CCK-2874.00-3-25

New Environmental Quality Management Center

ADDENDUM #3

ADDENDUM #3

FIRST FLOOR PLUMBING UNDERSLAB PLAN
18" = 1'-0"

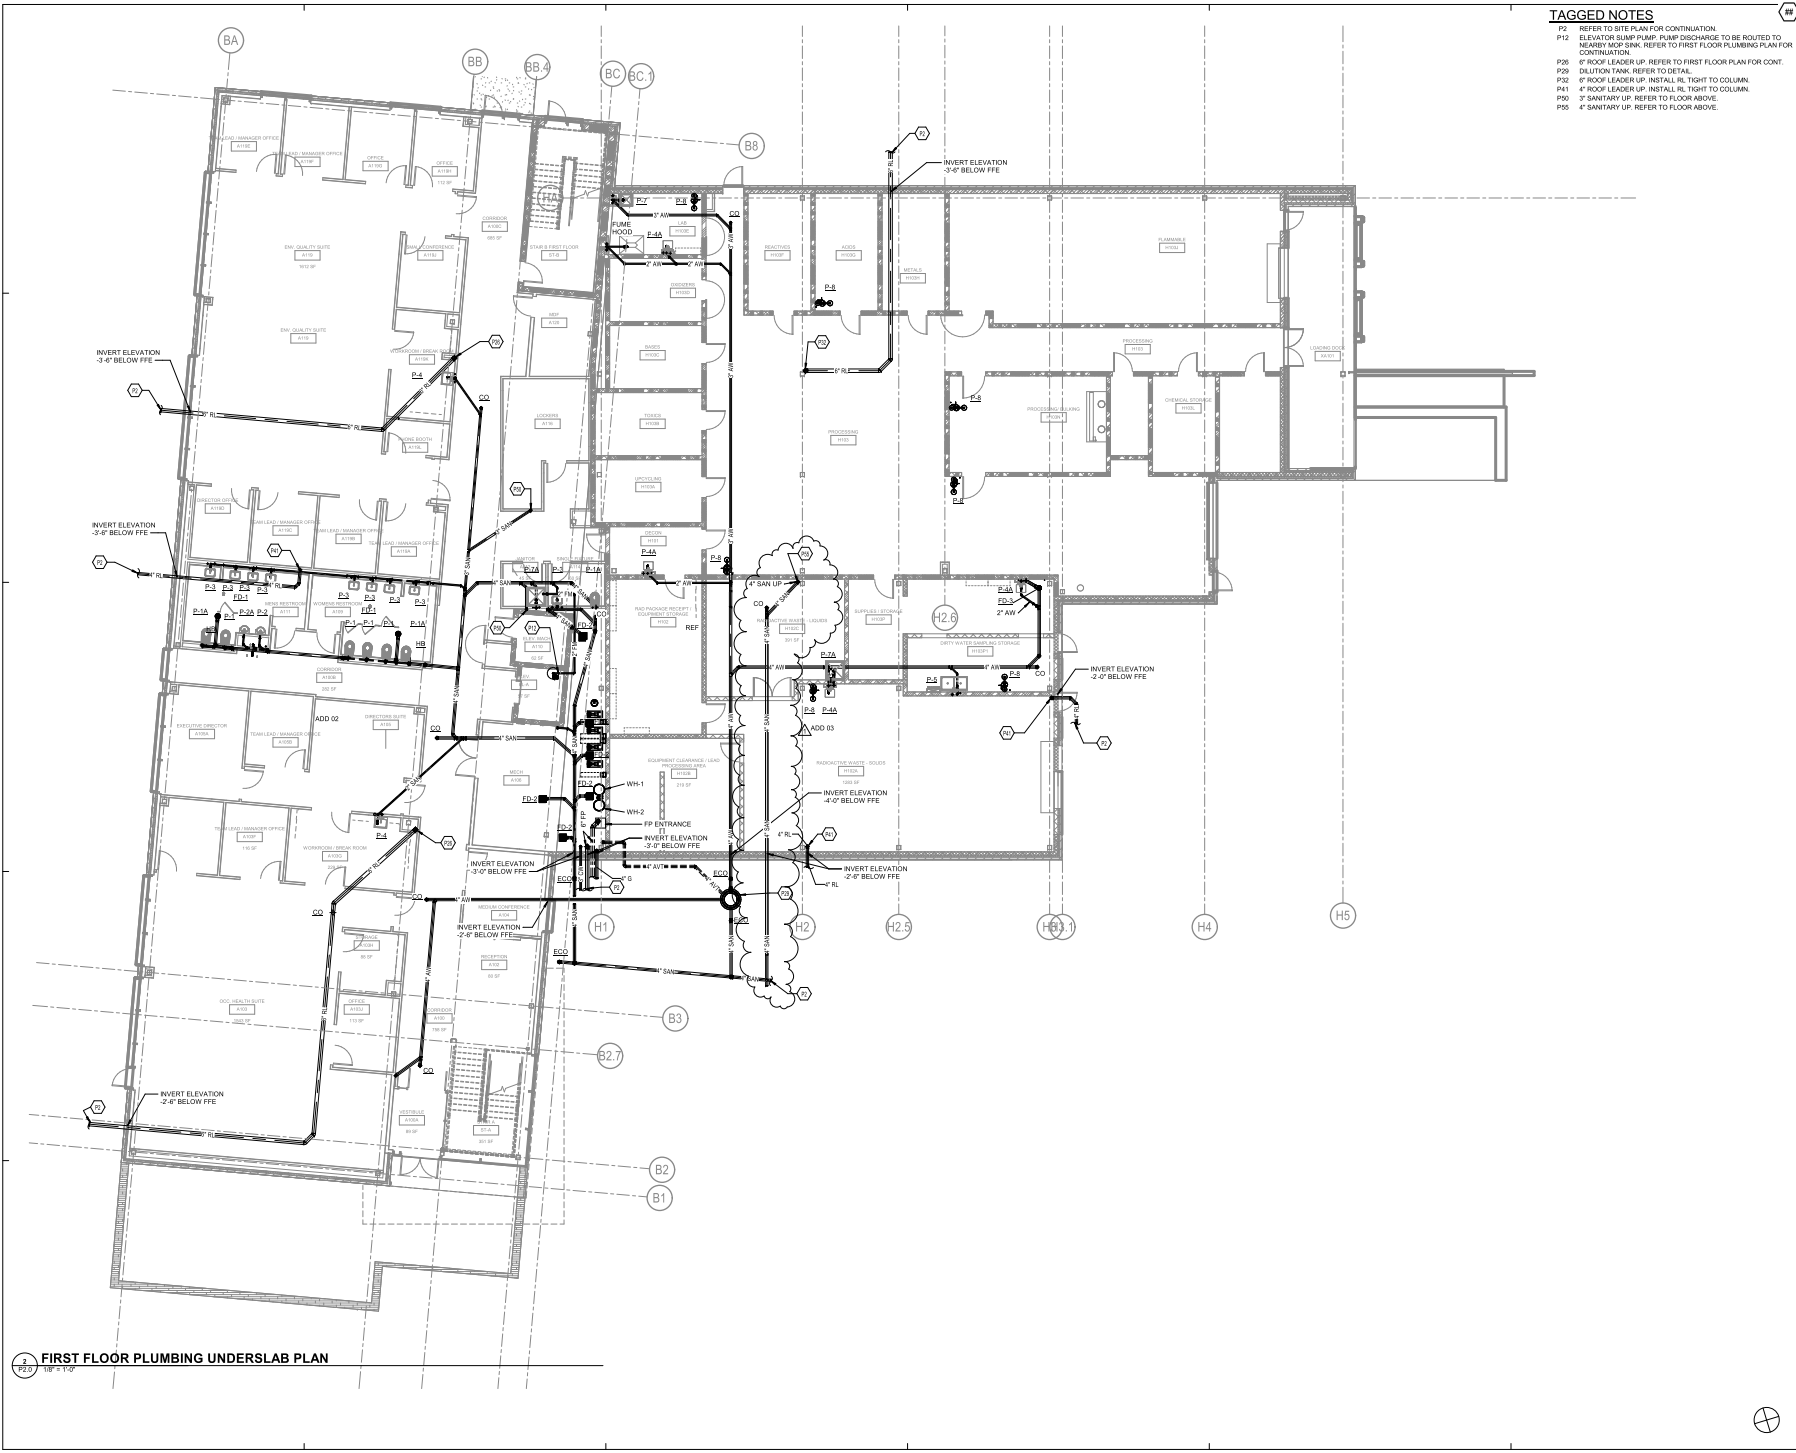
- Item #12 Refer to attached sheet P2.0
A. Change acid waste piping serving floor drains in second floor mechanical room to sanitary piping. Revise layout on attached sheet.

SECOND FLOOR PLUMBING PLAN - BASE BID

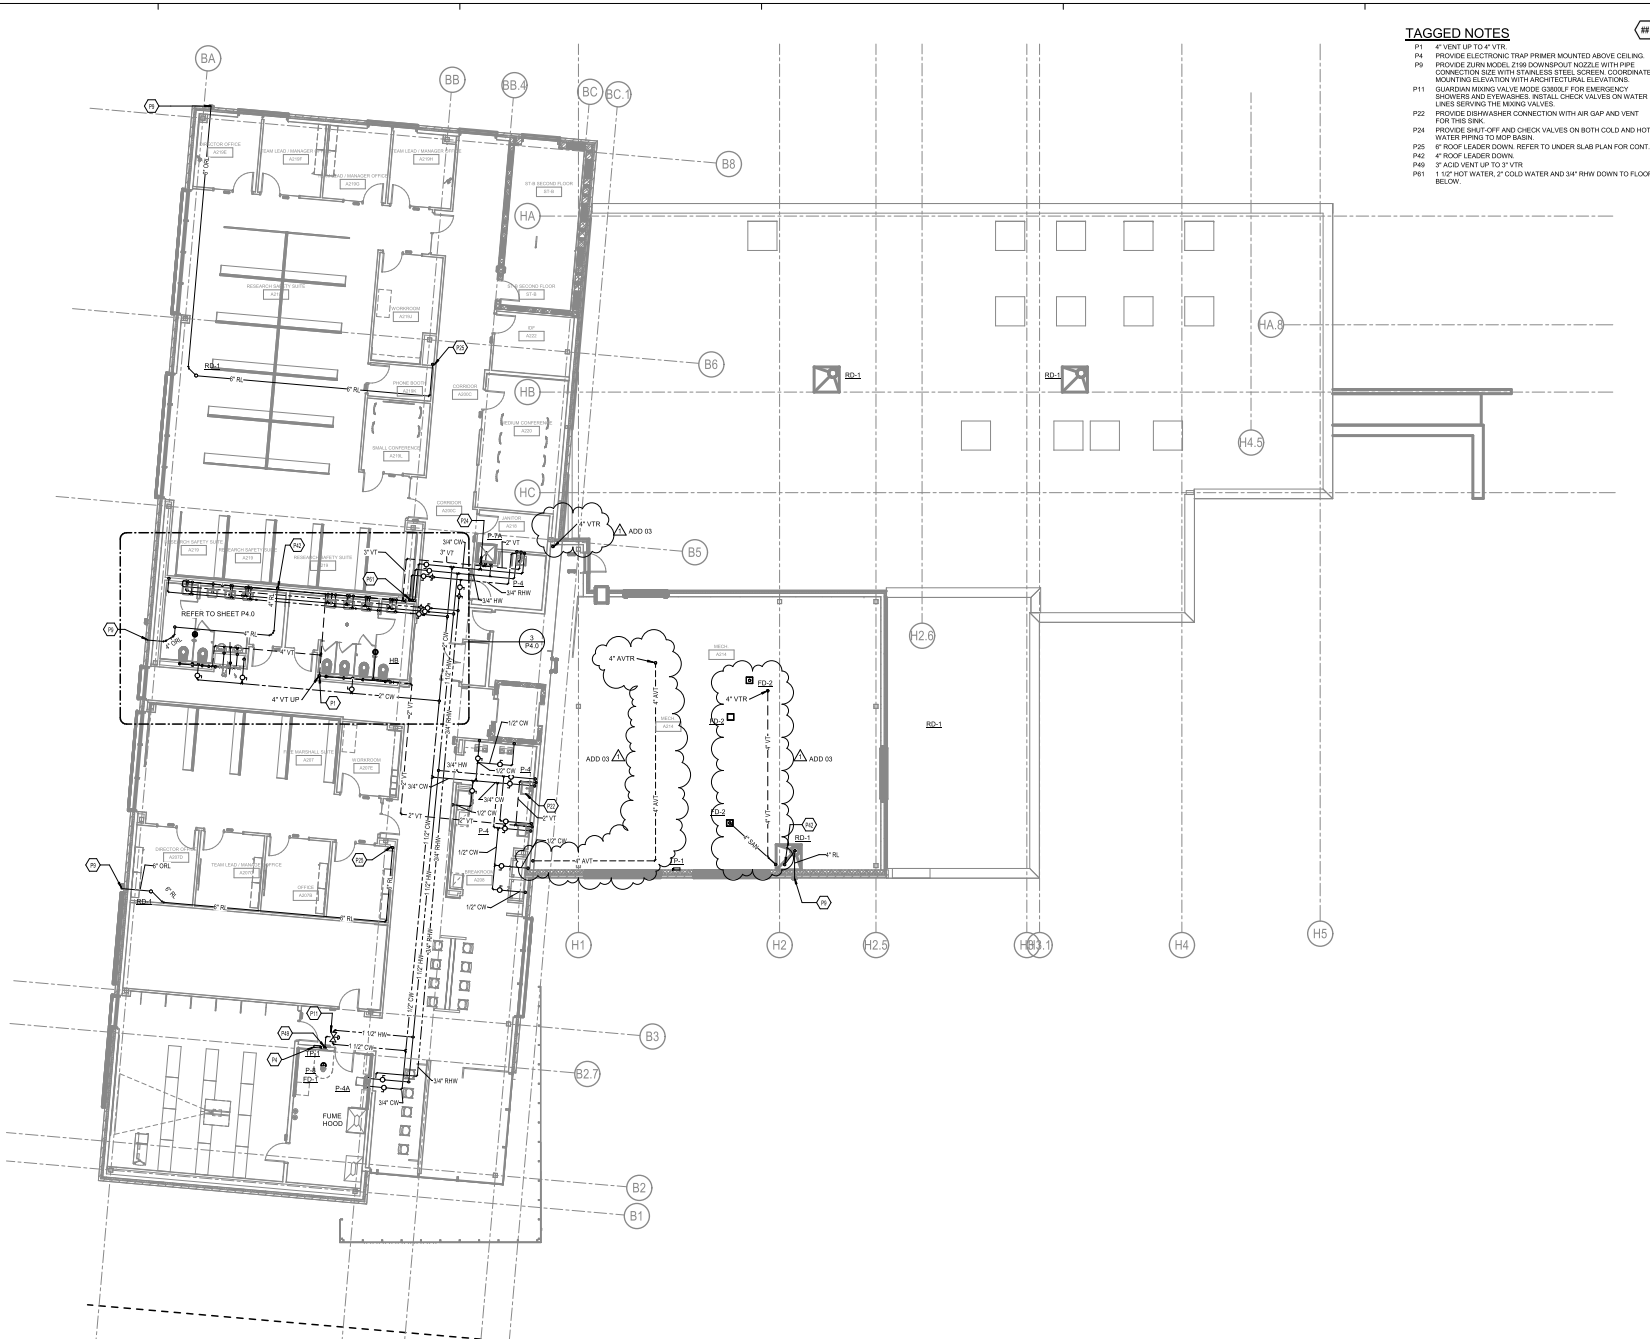
K. Add ¾" recirc. hot water line with ball valve and balancing valve to P-4 in room A119K.
- Item #14 Refer to attached sheet P3.1
A. Revise location of acid vent through roof away from air intakes.

B. Revise location of acid vent through roof away from air intakes.

- C. Revise location of vent through roof at column line B5.
- D. Change 2" acid vent through roof to 4" acid vent through roof.

P3.1A

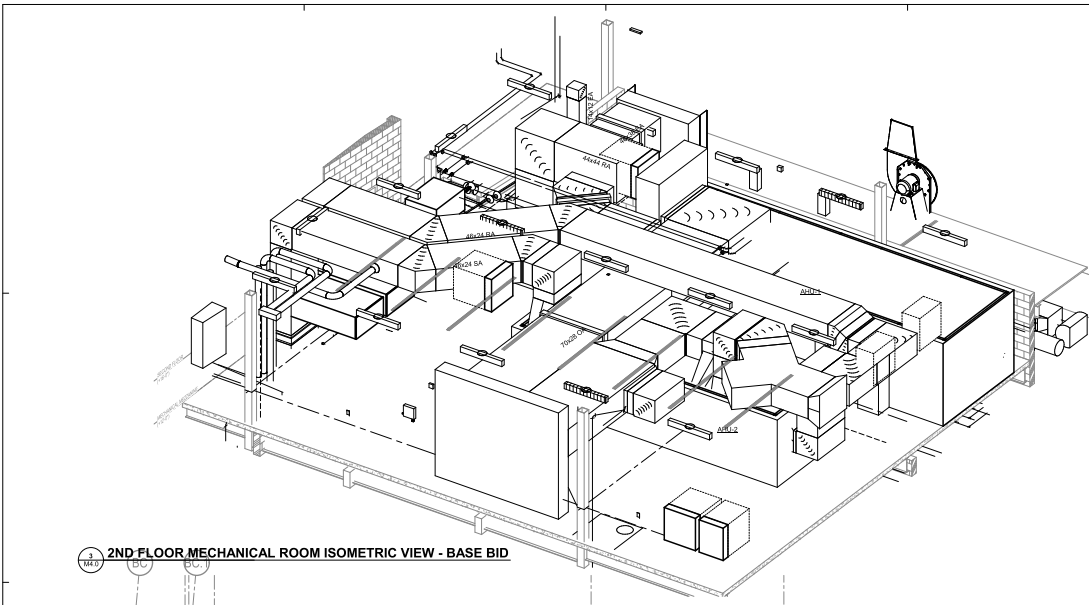
Item #15 Refer to sheet P3.1A

- A. Provide ¾" RHW lines with ball valves and balancing valves to P-4 sinks in room A208.

FIRST FLOOR ENLARGED MECHANICAL ROOM

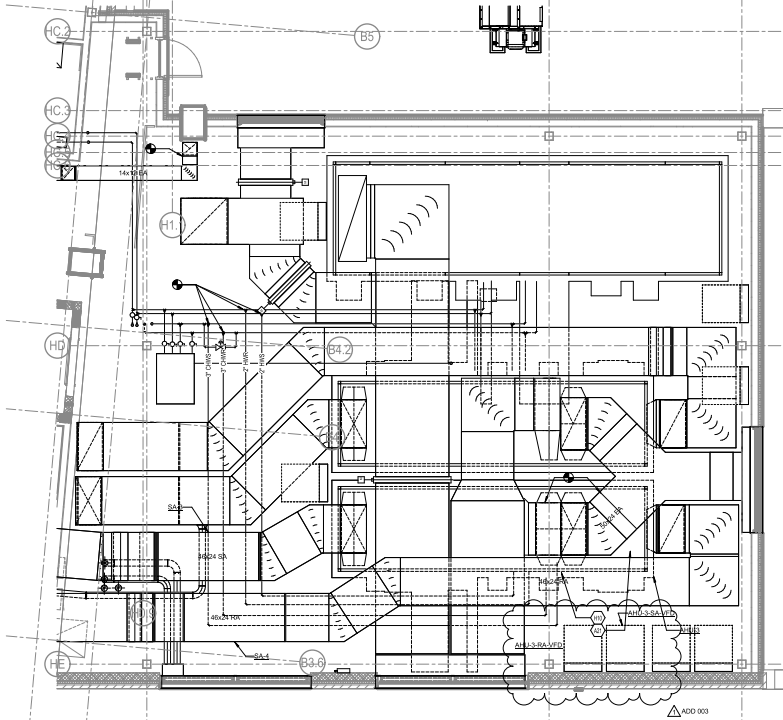
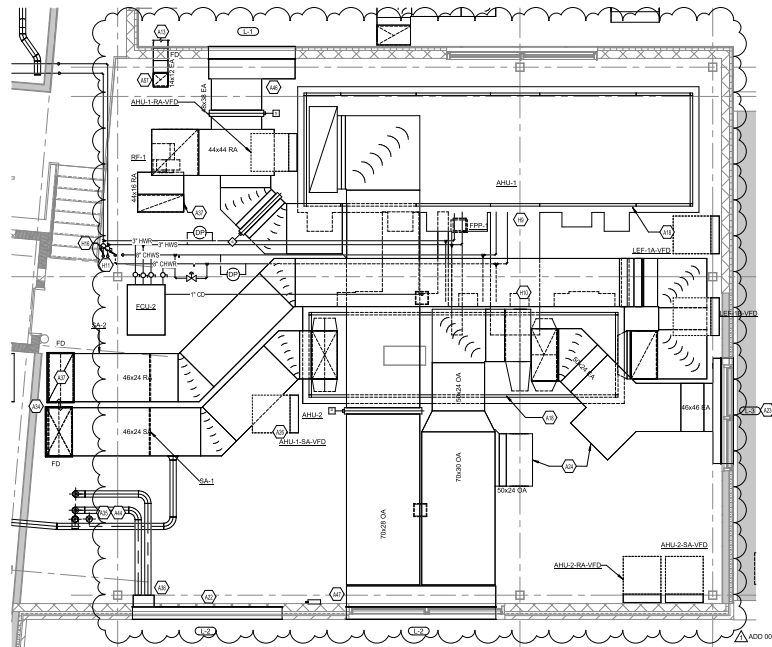
- Item #1 Refer to sheet attached sheet M4.0 and M8.0
A. Provide VFDs in locations shown in the mechanical room on the second floor. Rename VFDs in the first-floor mechanical room as sheet M4.0 indicates. See VFD schedule on sheet M8.0.
